**WHISPERING WINDS DR. AND DUNES AVE.
FROM MOGFORD TO RIPTIDE
Solicitation Number: CO-00192
Job No.: 17-7004**

**ADDENDUM 1
July 6, 2018**

WHISPERING WINDS WATER LINE STA 10+00 TO STA 14+00

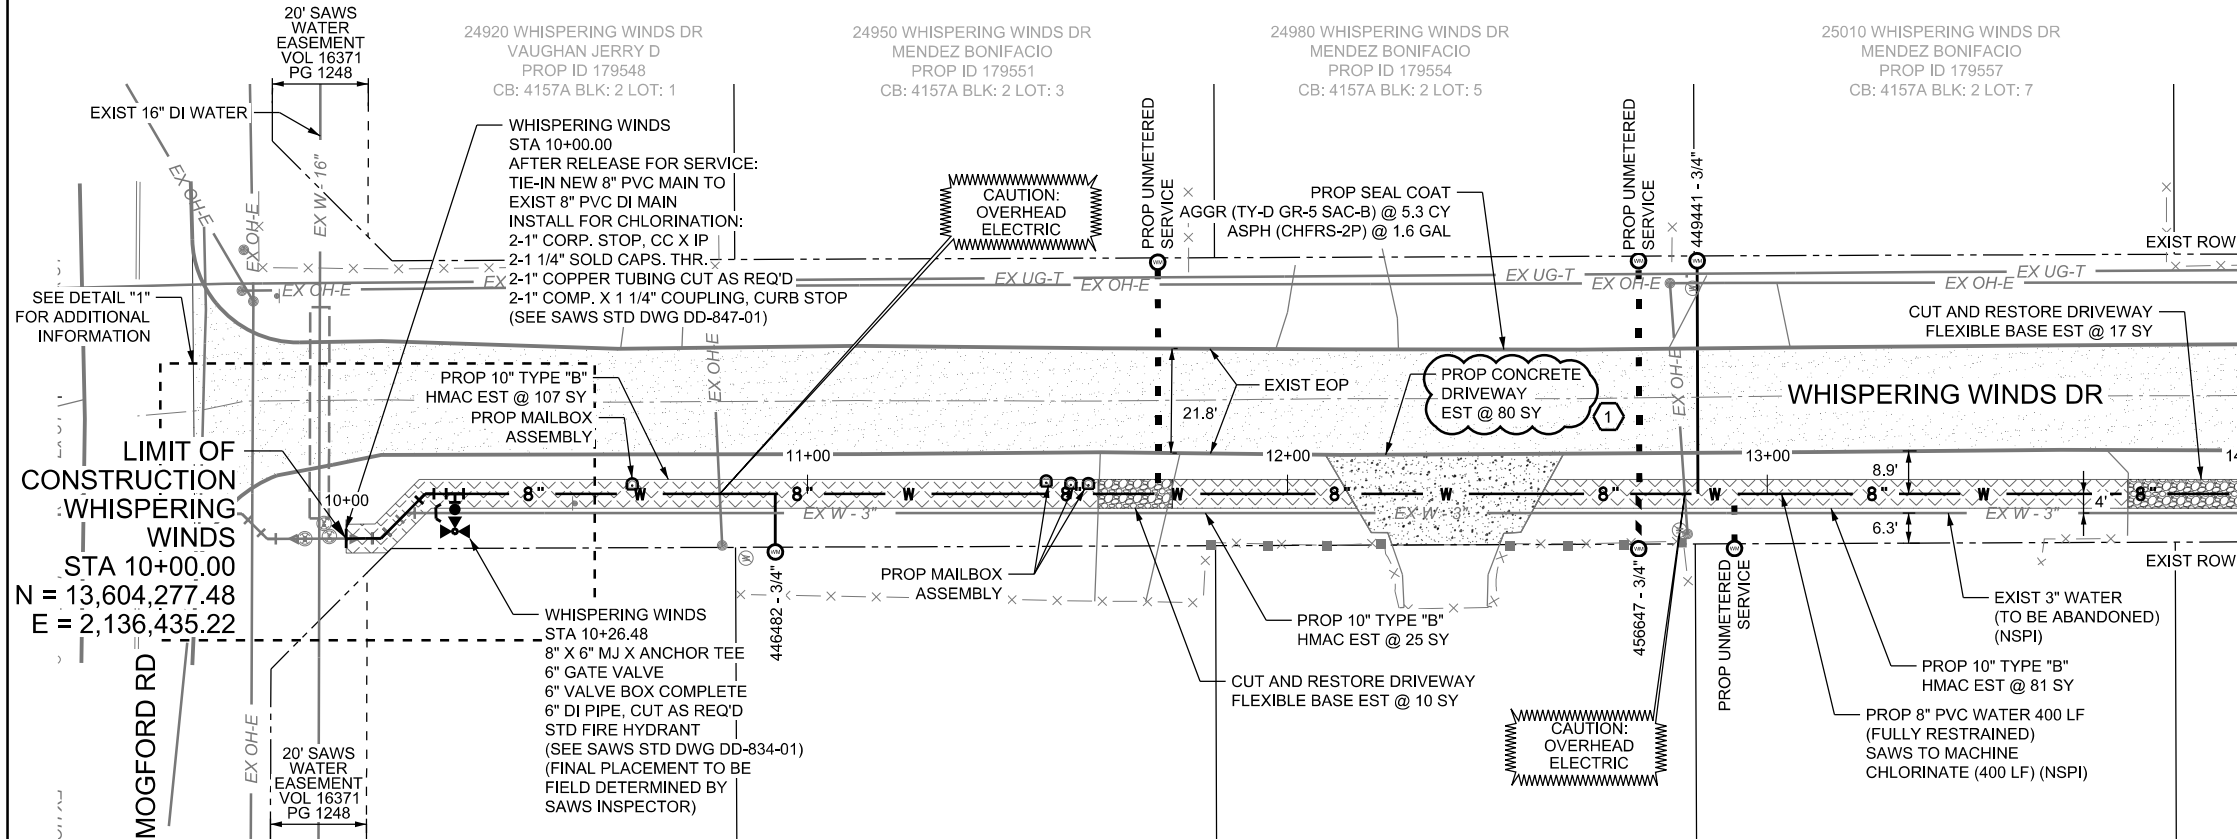
2. Plan Sheet 9 of 58 - Replaced sheet dated 06/08/2018 with attached sheet 07/05/2018. Updates to plan sheet consists of updating description and revising quantity of CoSA Item No. 503.1 Portland Cement Concrete Driveways (100 SY < X < 10,000 SY).

1 ADDENDUM 1 (07-05-2018) - UPDATED DESCRIPTION AND REVISED QUANTITY OF COSA ITEM NO. 503.1 PORTLAND CEMENT DRIVEWAYS (100 SY < X < 10,000 SY).

WHISPERING WINDS WATER LINE STA 18+00 TO STA 22+00

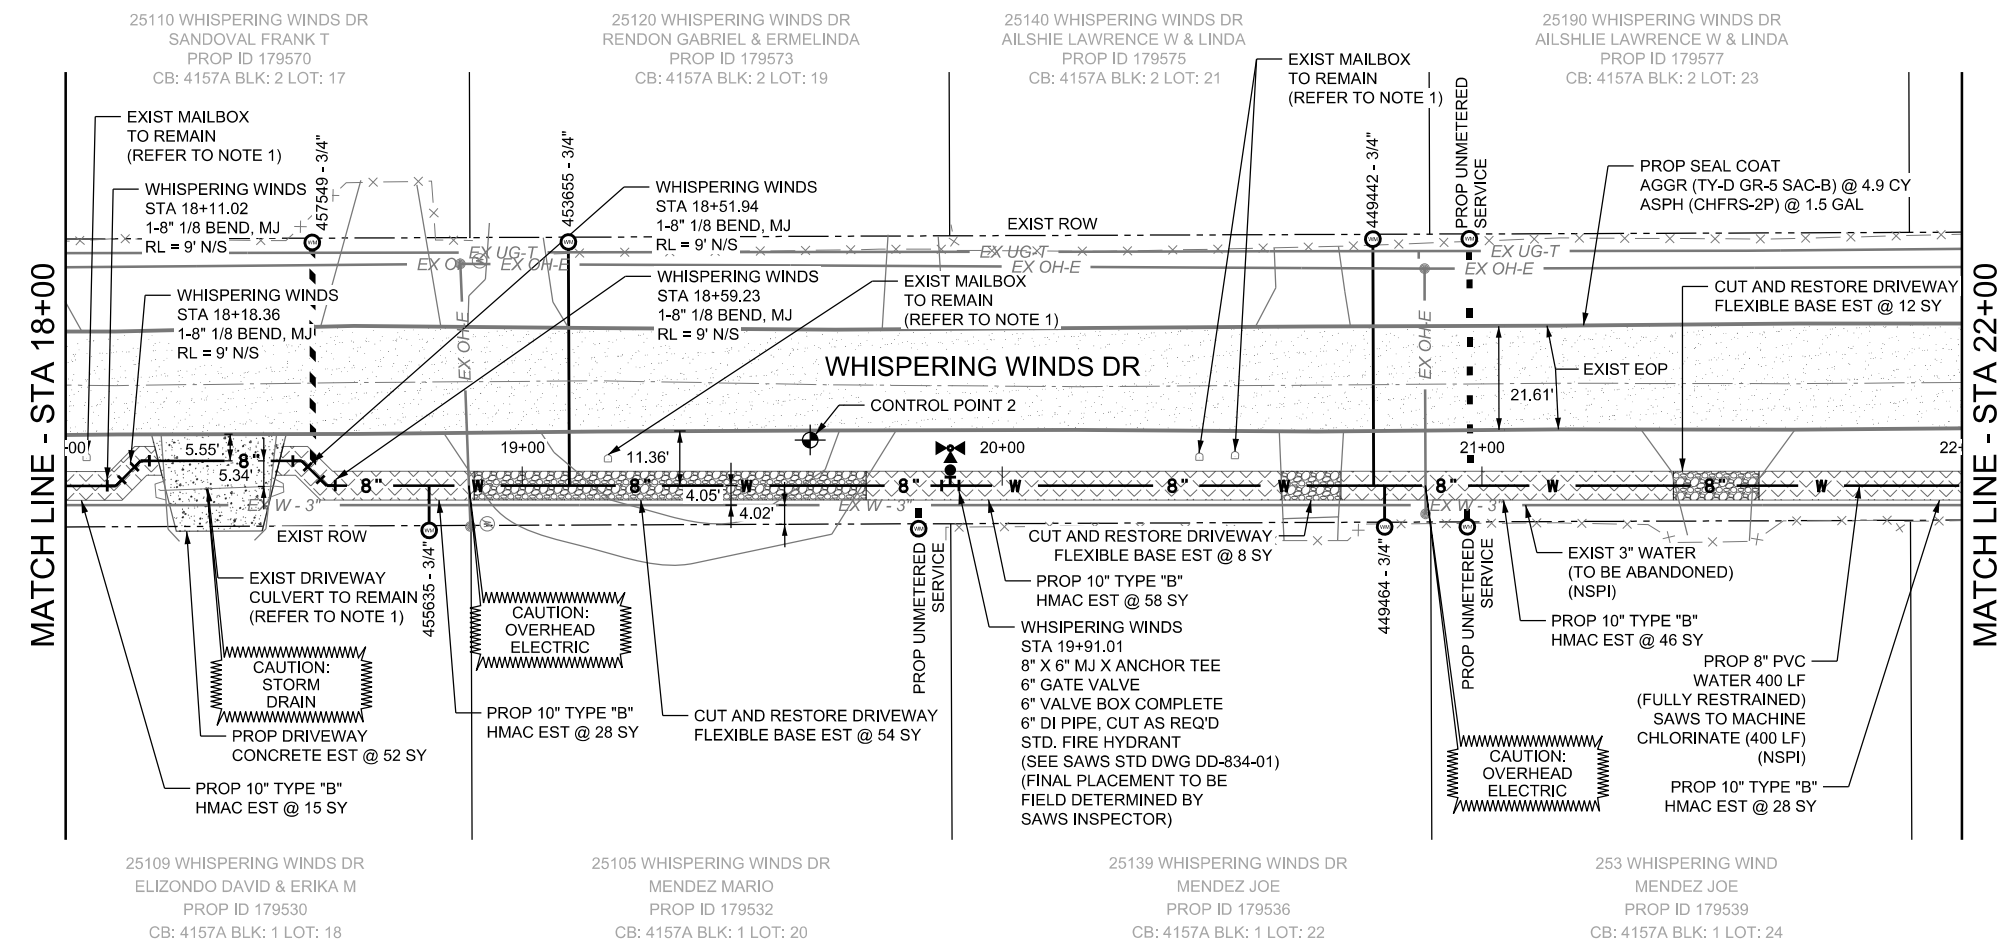
3. Plan Sheet 11 of 58 - Replaced sheet dated 06/08/2018 with attached sheet 07/05/2018. Updates to plan sheet consists of updating description of CoSA Item No. 503.1 Portland Cement Concrete Driveways (100 SY < X < 10,000 SY).

1 ADDENDUM 1 (07-05-2018) - UPDATED DESCRIPTION OF COSA ITEM NO. 503.1
PORTLAND CEMENT CONCRETE DRIVEWAYS (100 SY < X < 10,000 SY).

DUNES WATER LINE STA 46+00 TO STA 50+00

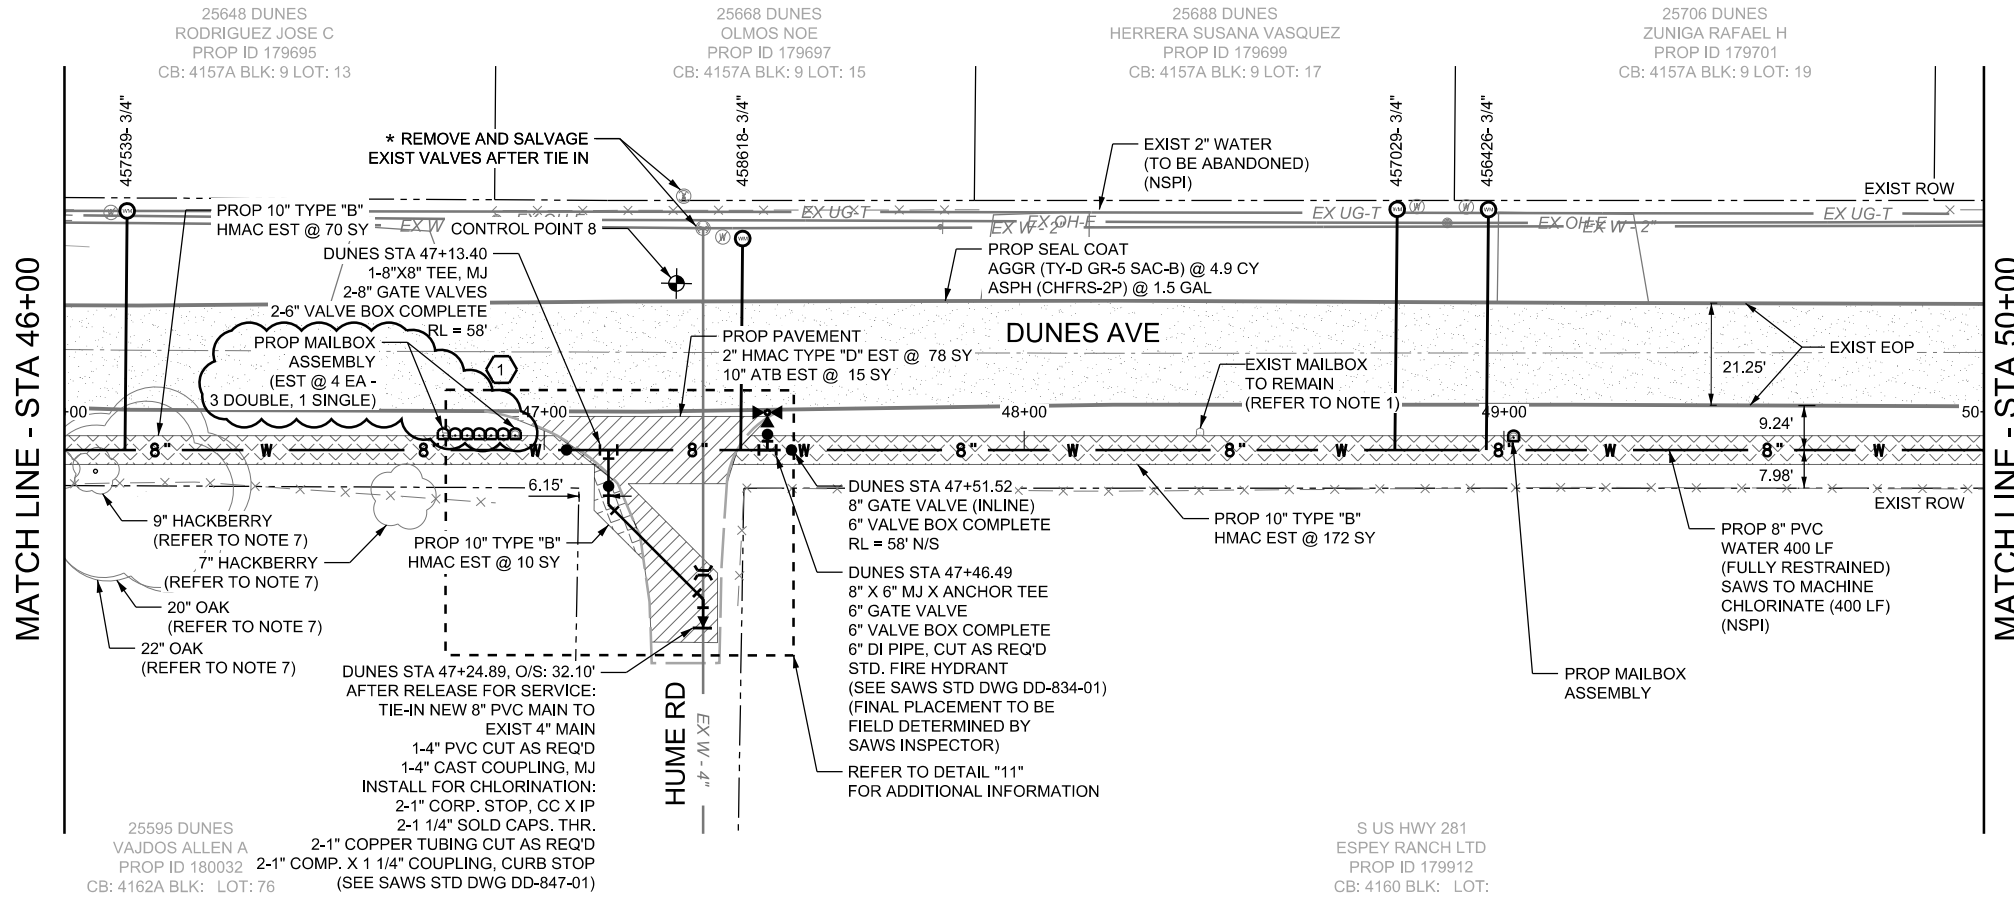
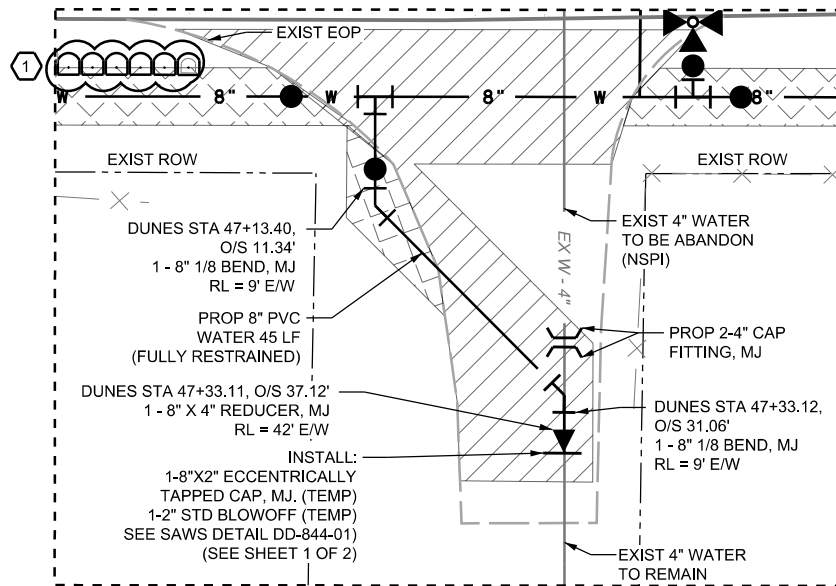
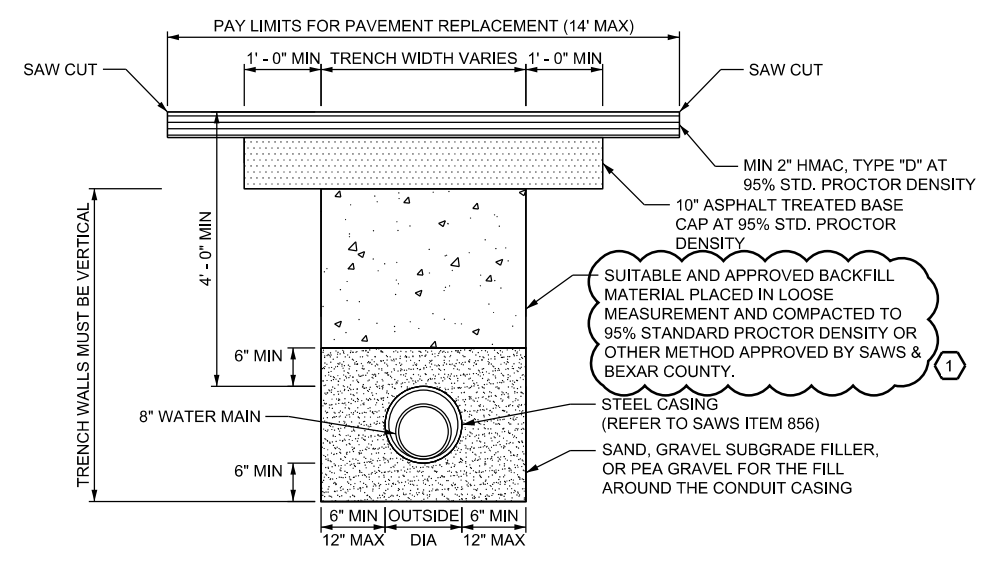
2. **Question:** On Sheet 35, regarding the mailbox detail. Please identify which detail is applicable for the 47 EA items to be installed, singular, communal, etc...

4. Plan Sheet 29 of 58 - Replaced sheet dated 06/08/2018 with attached sheet 07/05/2018. Updates to plan sheet consists of updating plan view callouts of Prop Mailbox Assemblies at Hume Rd, removing callout for Exist Mailbox to Remain, and adding quantity of TxDOT Item No. 560 2002 Mailbox Assemblies (Double).

1 ADDENDUM 1 (07-05-2018) - UPDATED CALLOUTS OF PROP MAILBOX ASSEMBLIES AT HUME RD, REMOVED CALLOUT FOR EXIST MAILBOX TO REMAIN, AND ADDED QUANTITY OF TXDOT ITEM NO. 560 2002 MAILBOX ASSEMBLIES (DOUBLE).

Response: The intent is to replace the majority of existing mailboxes with single mailbox mount. There is one (1) exception located on the northwest corner of the intersection between Dunes Ave and Hume Road where there are seven (7) existing mailboxes in a row. These will be replaced with 3-double mailbox mount and 1-single mailbox mount (plans have been updated to reflect this change).

MISCELLANEOUS DETAILS 1

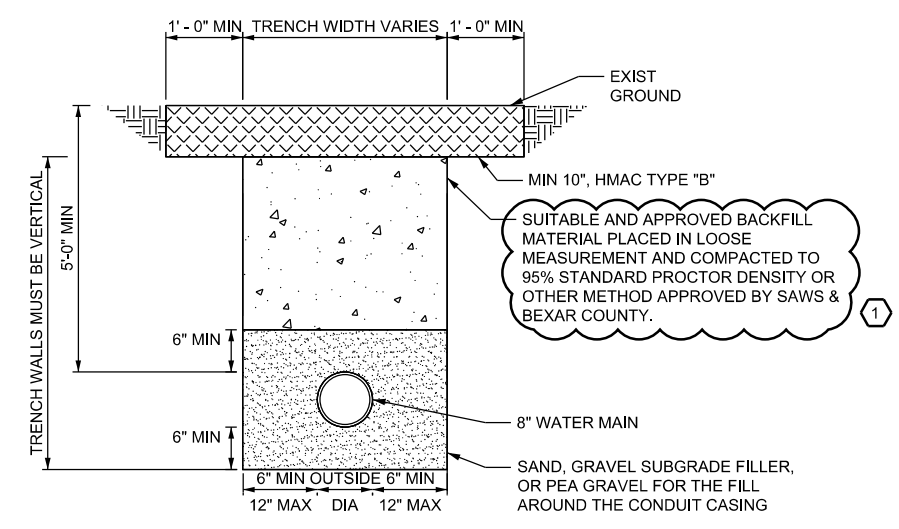
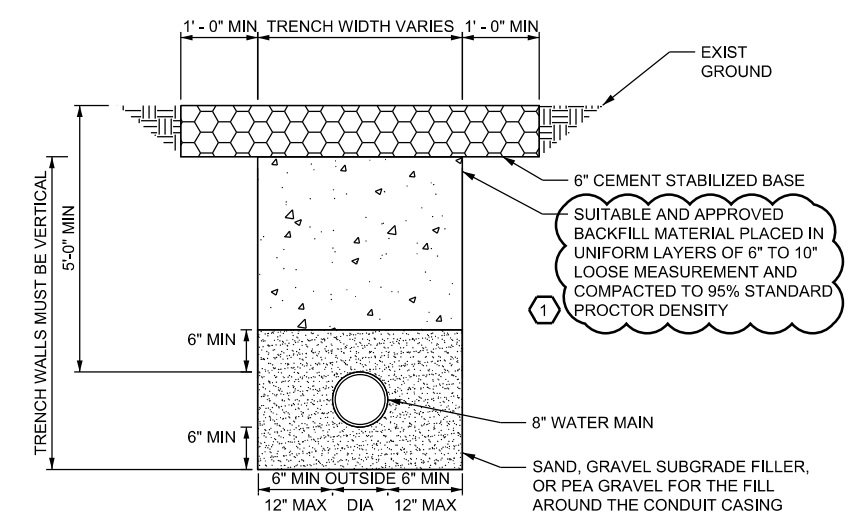
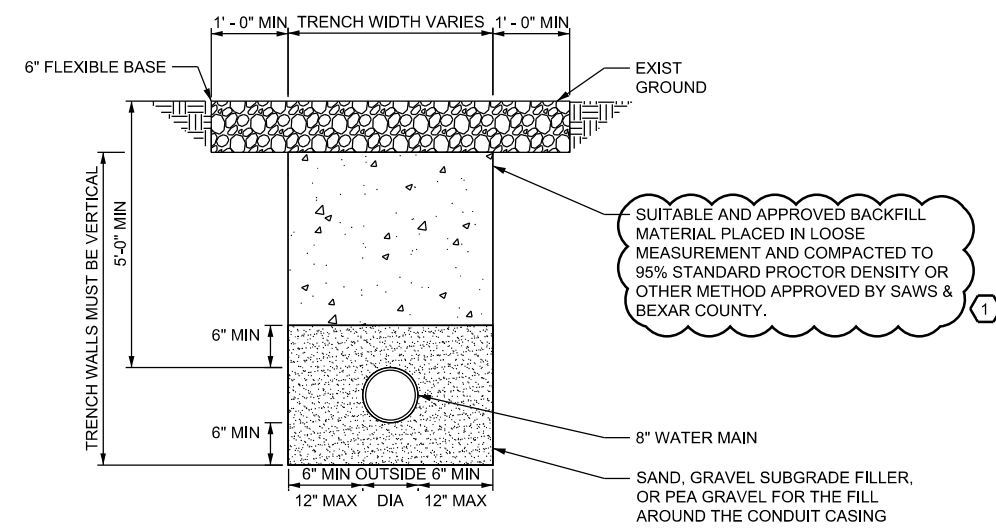
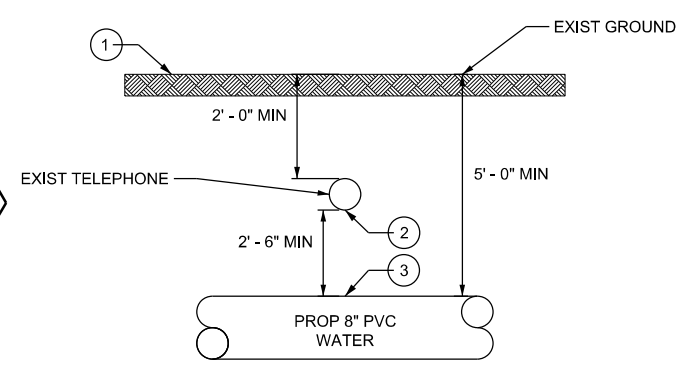
3. **Question:** Sheet 33 – concerning the profile detail of the water pipe, SAND is acceptable as the primary backfill of the water main, correct?

12. **Question:** Sheet 33 refers to compacted material as secondary backfill or quickest flash fill- is there a specification for this material available?

5. Plan Sheet 33 of 58 – Replaced sheet dated 06/08/2018 with attached sheet 07/05/2018. Updates to plan sheet consists of removing Quickest Flash Fill reference on primary backfill note and adding approval by SAWS & Bexar County on all details.

1 ADDENDUM 1 (07-05-2018) - REMOVED QUICKEST FLASH FILL REFERENCE ON PRIMARY BACKFILL NOTE AND APPROVAL BY SAWS & BEXAR COUNTY ON ALL DETAILS.

Response: Typical Pavement Details are a reflection of Bexar County Public Works trench minimum requirements which state Sand, Gravel Subgrade Filler, or Pea Gravel for the fill around the water main and services to a minimum of 6" above casing/pipe. Sand is acceptable for the primary backfill.

Response: Design plans have been updated to remove quickest flash fill as an alternative method and specification, measurement, and payment will no longer be required.
